REPORT TO THE CALGARY PLANNING COMMISSION

DEVELOPMENT PERMIT	ITEM NO: 04	
	CPC DATE:	2008 May 01
	DP NO:	DP2007-4455

PROPOSAL: 8 storey mixed use development

DP-1.3

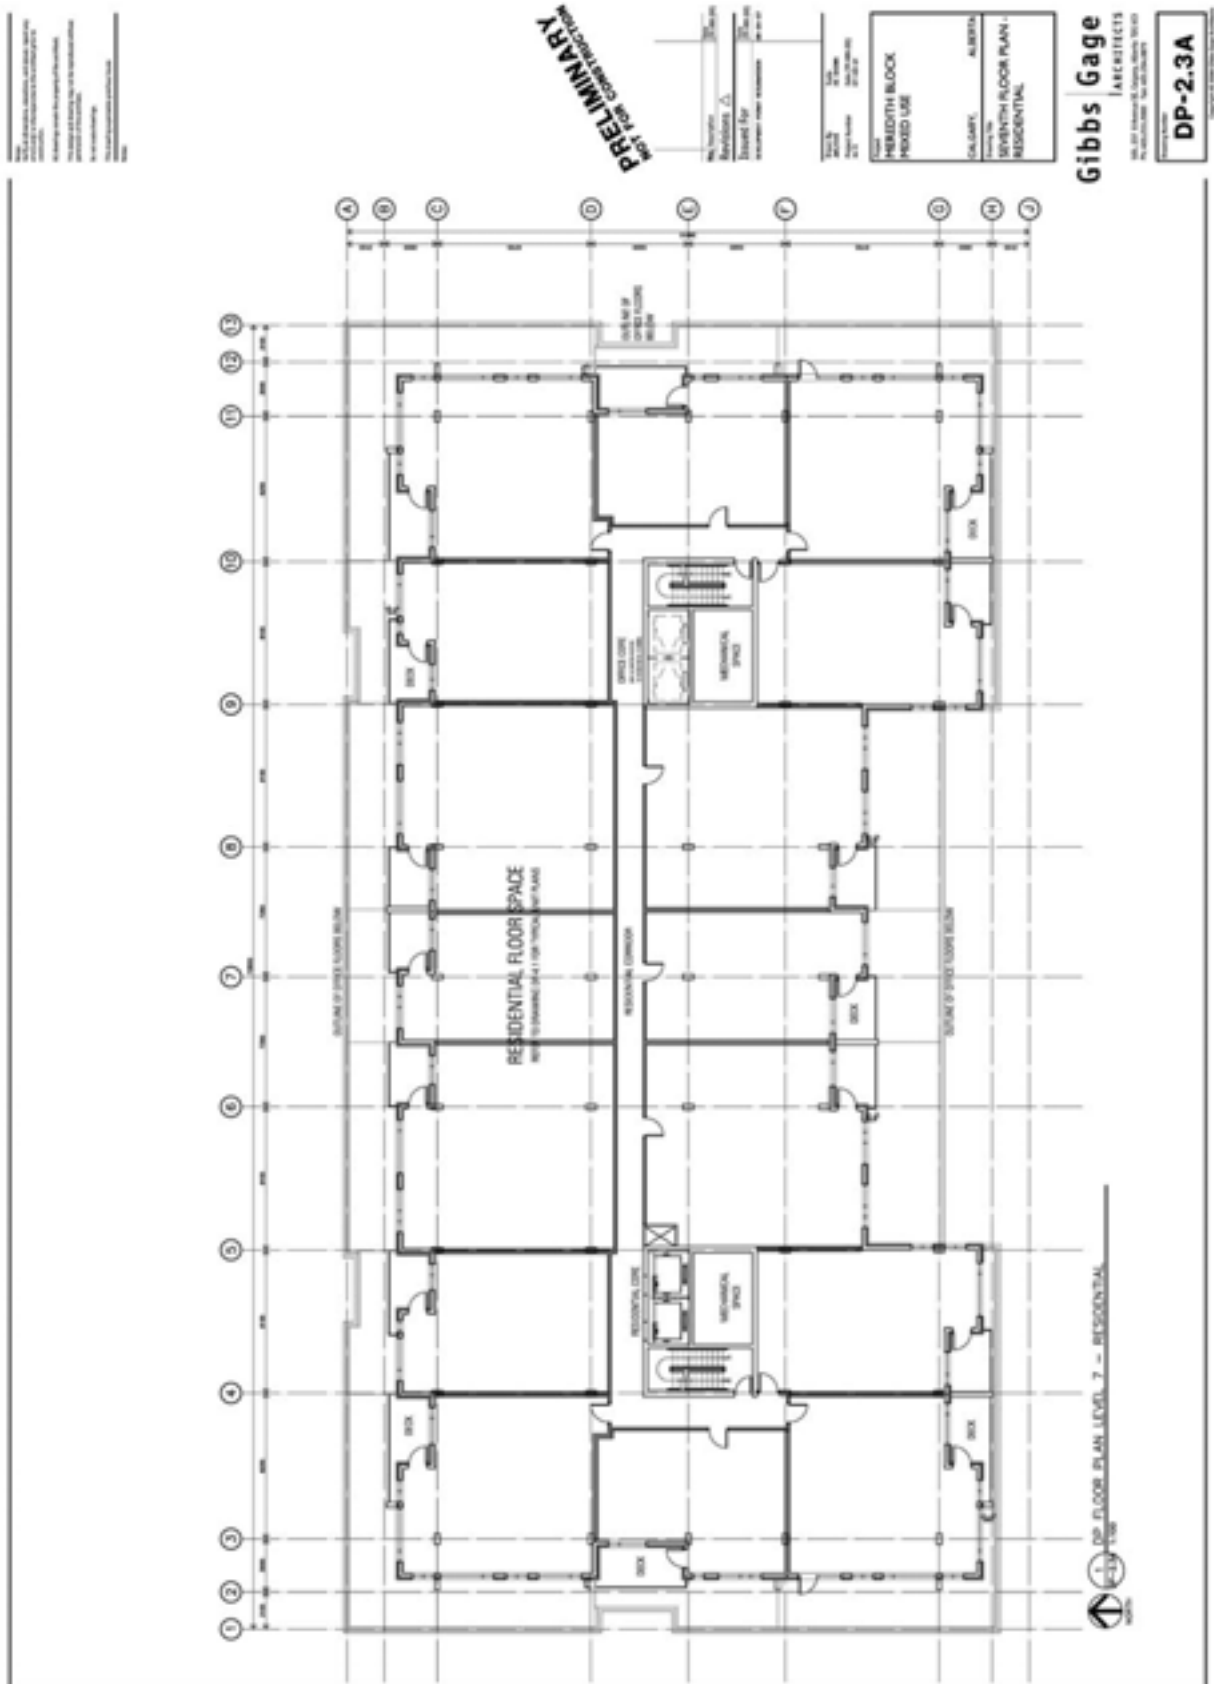
- a. Class 1 and 2 bike parking calculations on DP-1.1 are correct, except for Class 1 for office use. Use downtown requirements for office use: a minimum of one Class 1 (secure) bike parking stall shall be provided per 600 m² GFA, which results in 18 stalls required instead of 11 for a total Class 1 requirement of 39 bike parking stalls.
